**Item 4.****Development Application: 12-20 Rosebery Avenue, Rosebery - D/2025/184****File Number: D/2025/184****Summary**

<b>Date of Submission:</b>	5 March 2025  Amended plans received on 16 June 2025, 30 July 2025 and 27 August 2025
<b>Applicant:</b>	Rosebery Properties Pty Ltd
<b>Architect/Designer:</b>	WMK Architecture
<b>Developer:</b>	Rosebery Properties Pty Ltd
<b>Owner:</b>	Rosebery Properties Pty Ltd
<b>Planning Consultant:</b>	Willowtree Planning
<b>Heritage Consultant:</b>	Comber Consultants
<b>DAP:</b>	29 May 2025
<b>Cost of Works:</b>	\$100,646,700.00
<b>Zoning:</b>	MU1 - Mixed Use Zone  The proposal is for a mixed-use development, comprising a retail premises and residential flat buildings, which are permissible within the zone.
<b>Proposal Summary:</b>	Approval is sought for a mixed-use development comprising: <ul style="list-style-type: none"><li>• demolition of structures, site preparation and remediation works and removal of 14 trees</li><li>• the construction of two, 8 storey residential flat buildings, containing 143 residential units</li><li>• one level of basement car parking and one retail premises and</li></ul>

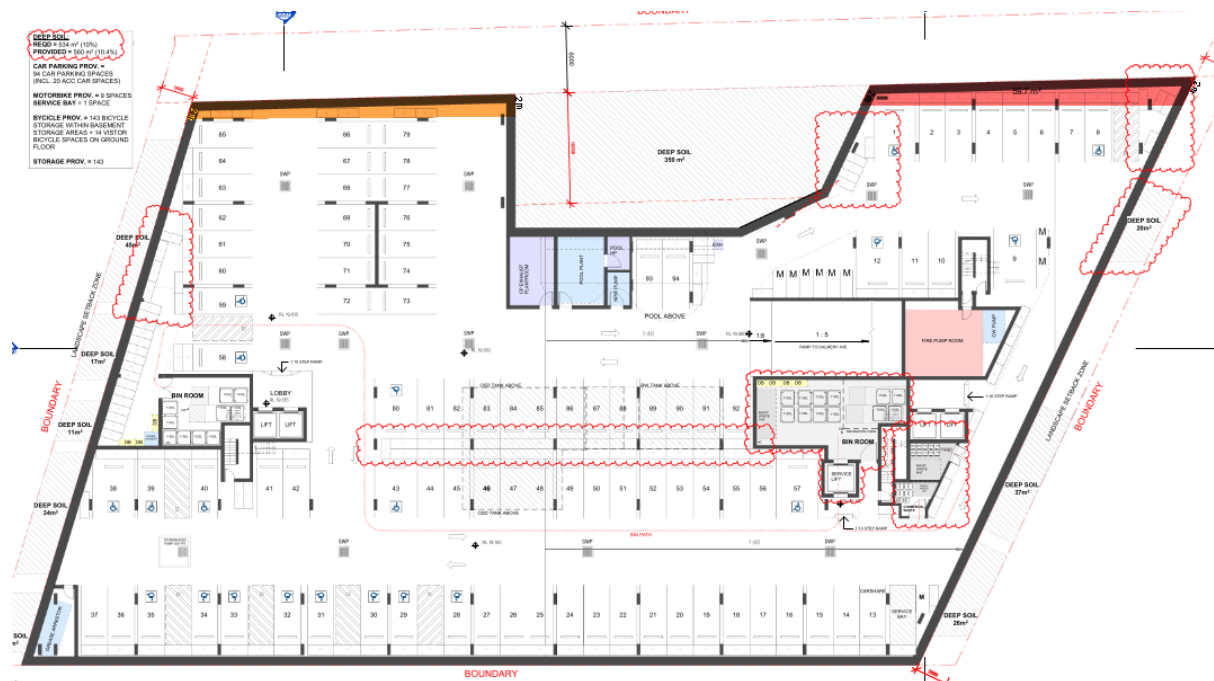
Design recommendations	
Recommendation	Comment
There is a lack of shading to the western apartments at level 5 and above and to the northern apartments at the lower levels. The	Minor changes were made in the amended plans to address the northern

Design recommendations	
Panel recommended that adequate shading be provided to these apartments.	<p>apartments but not the western apartments.</p> <p>A condition of consent is recommended to provide external shading to unprotected glazed areas of the northern and western elevations.</p>
There is an excess of hardstand area in the southern through-site link. The Panel recommended that this be softened with planting.	<p>The amended architectural drawings and landscape drawings reduce the footpaths and hardstand areas and provide landscaping and planting.</p> <p>The changes create a more permeable and environmentally responsive ground plane that enhances both ecological performance and visual amenity.</p>
At building B level 1, there is a large, north-facing blank wall which could be improved with more protected openings for the benefit of the apartments.	Protected glass openings have been thoughtfully integrated into the northern apartments, transforming previously blank wall areas into dynamic facade elements that enhance natural light penetration and visual connectivity whilst maintaining privacy and security standards.

**Figure 11:** Indicative 2m setback for the basement level, outlined in red and orange

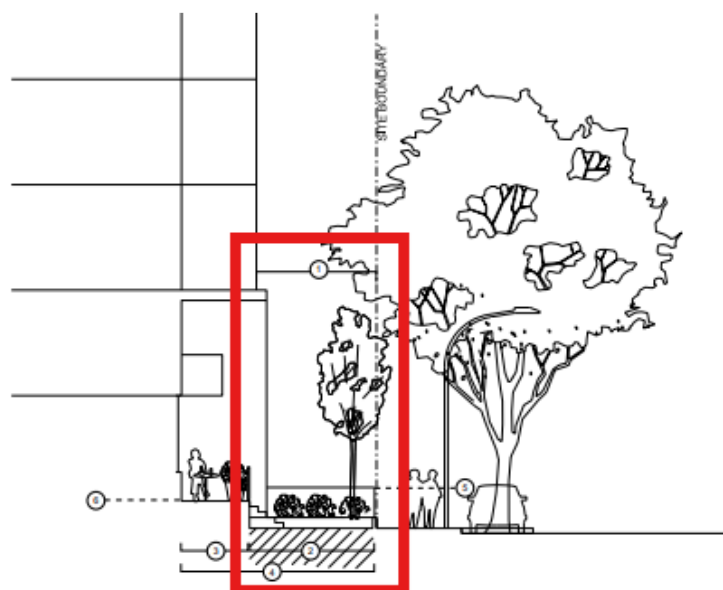
67. Section 5.7.2.1 of Sydney DCP sets out the site specific building setbacks for the subject site. In accordance with this section, a 2m deep soil landscape setback is required for the northern boundary. The current basement design encroaches into this setback as shown below:

68. The Jury Report for the design excellence competition recommended that a 2m deep soil landscape setback be provided to the northern laneway. Further to this, Council required this to be addressed via pre-lodgement advice in 2023, 2024 and the 2 subsequent requests for additional information letters during the assessment of the subject application.
69. The amended set of architectural plans removed the footpaths and other hard stand pavement on the ground floor that encroached into this area however, the basement level was not setback.
70. To address the above and satisfy the jury comments and achieve compliance with the site specific DCP, a design modification condition has been recommended to provide a 2m deep soil setback to the basement level.

**Figure 14:** Studio apartment BG.04 to be deleted, highlighted in yellow

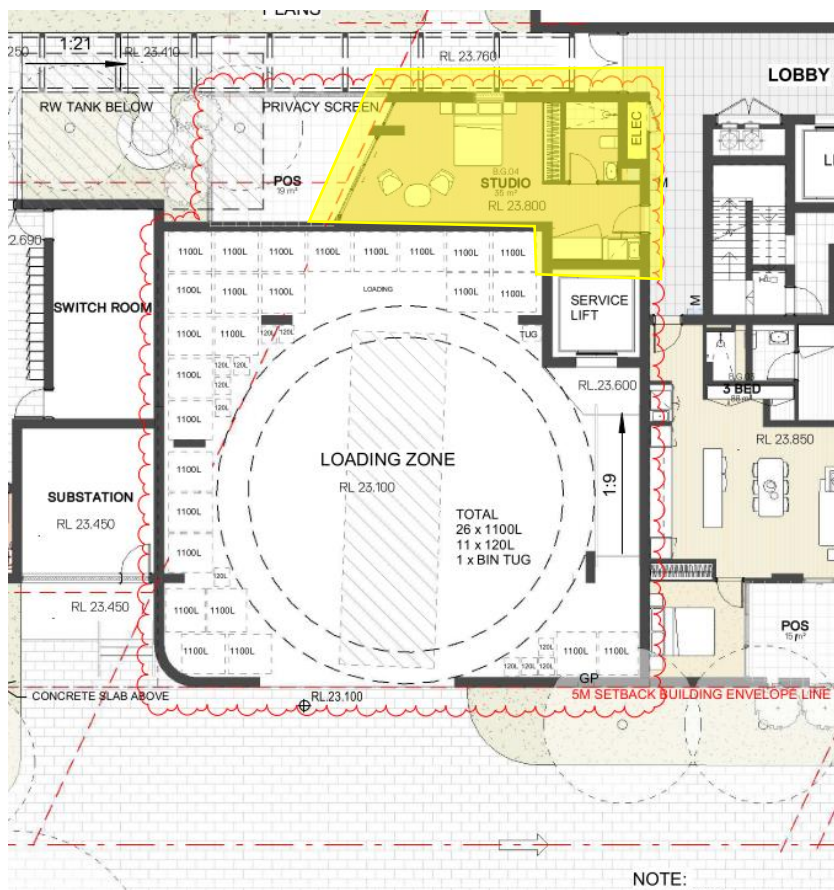
71. The current waste management arrangements for the ground floor loading dock does not involve a separate and dedicated waste holding area but rather proposes to place all the bins within the loading dock, around the turntable, see image of floor plan below:

72. As shown above, the amended plans have only provided space for the waste collection vehicle without providing spatial considerations for an orderly waste holding area and therefore, the area cannot be serviced in a disorderly fashion as the bins would huddled around and overhanging the turntable.

73. The current proposal is not acceptable. To address this issue, a design modification condition is recommended which requires the studio apartment (highlighted yellow in the above figure) at the rear of the loading dock be replaced with a waste holding area. Plans provided in 2023, post design competition showed the loading dock with no studio at the rear and this arrangement provided more space for the orderly serving of the site.
